SPECIAL MEETING AGENDA

1. CALL TO ORDER
2. ROLL CALL
3. APPROVAL OF AGENDA
4. APPROVAL OF THE MAY 12TH, 2026 REGULAR PLANNING COMMISSION MEETING MINUTES
5. PUBLIC HEARINGS
 - A. **CLASS A NONCONFORMING DESIGNATION – CAR WASH “GROVE STREET AUTO WASH” – 2171 GROVE ROAD** – TO CONSIDER THE CLASS A NONCONFORMING DESIGNATION APPLICATION TO PERMIT THE RENOVATION OF A VEHICLE WASH OF AN EXISTING LEGAL NONCONFORMING STRUCTURE

**Preliminary Site Plan, Special Land Use, and
Class A Non-Conforming Designation Review
For
Ypsilanti Township, Michigan**

Applicant:	Blackstar Building Group, Inc.
Project Name:	Grove Rd. Car Wash Renovation
Plan Date:	December 30, 2025
Latest Revision:	March 17, 2026
Location:	2171 Grove Road (south of Lakeview Ave.)
Zoning:	GB, General Business District
Action Requested:	Preliminary Site Plan, Special Land Use, Class A Non-Conforming Designation Approval

PROPOSED LANDSCAPE PLAN FOR:
PROJECT NUMBER: 250926
DRAWN BY: Joyce E. Weise P.L.A., A.S.L.A.
DRAWING DATE: 011426
ISSUED FOR: 01/18/26 Site Plan Approval
02/18/26 Per Top. Comments
SCALE: 1"=20'
SHEET NUMBER: L-101

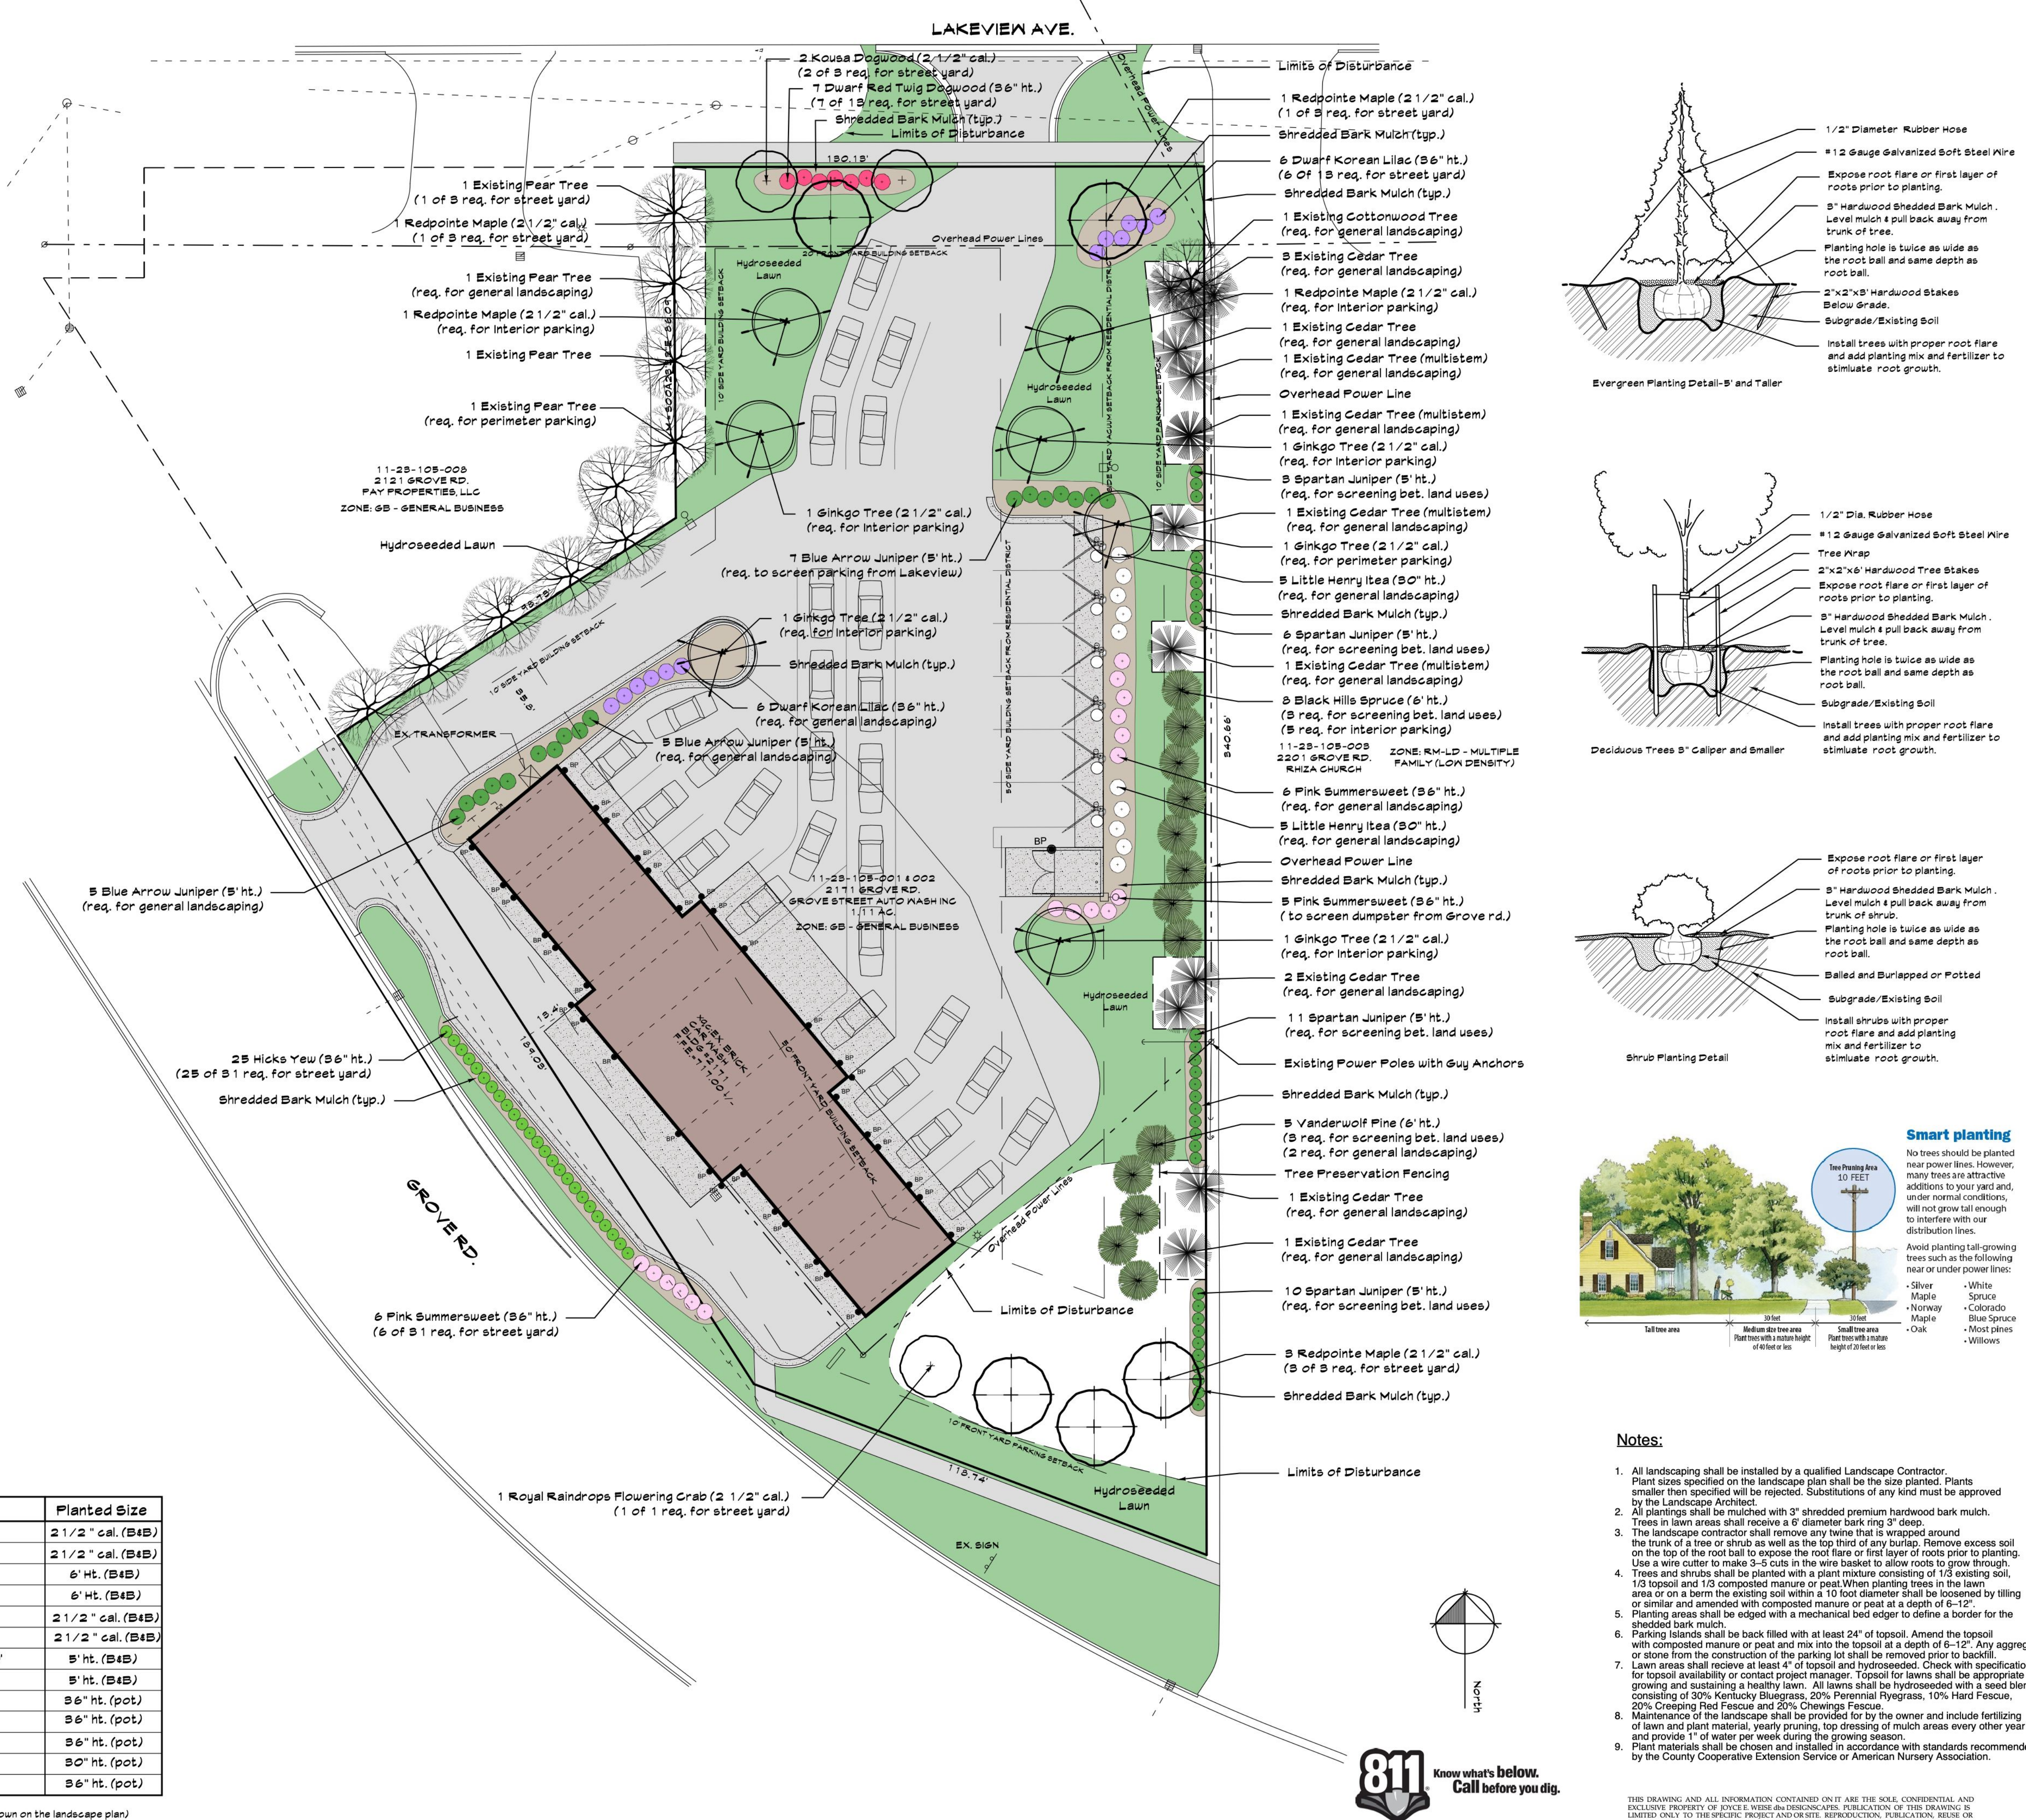
This project site abuts a residential district on the east side. While the ordinance requires a screen wall, Sheet L-101, *Landscape Plan*, shows preservation of most of the existing trees along the east side of the site and the addition of evergreen trees along this property line. The Planning Commission may consider the proposed landscape screen sufficient as an alternative to a 6-foot-tall wall. If landscaping isn't sufficient on its own, the Commissioners may also consider additional alternatives (such as a fence in addition to the landscaping) if necessary.

The proposed sizes of the plant material meet the minimum ordinance requirements. As required, more Vanderwolf Pine trees have been added to create better screening between this use and the next door church.

Sec. 1302(2)(D) calls for shrubs to screen the enclosure from view of the road. The Landscape Plan has been amended to provide shrubs on the south side of the dumpster enclosure that faces Grove Rd.
